Gatwick Airport Northern Runway Project

Examination Ref: TR020005

Joint Local Authorities' Response to the Applicant's Deadline 7 Submissions

Deadline 8: 7 August 2024

Figure A5.1 Air traffic and local employment are positively correlated

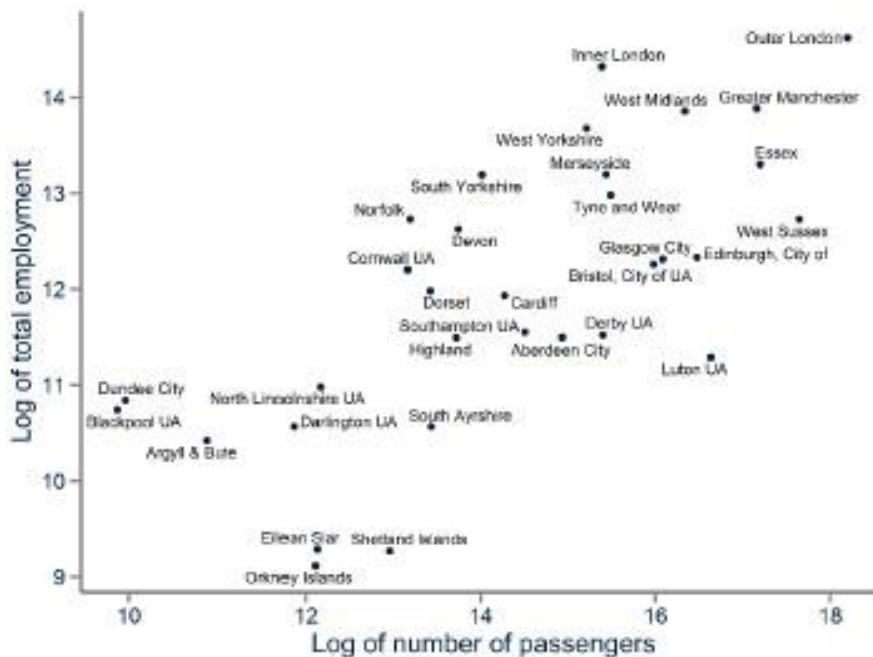
8. Problems arise from the different scale effects of the areas used - for Luton UA is a fundamentally smaller area than Greater Manchester and the relationship of each to their local airports is different. For example, it is not clear how these overlaps in catchment area
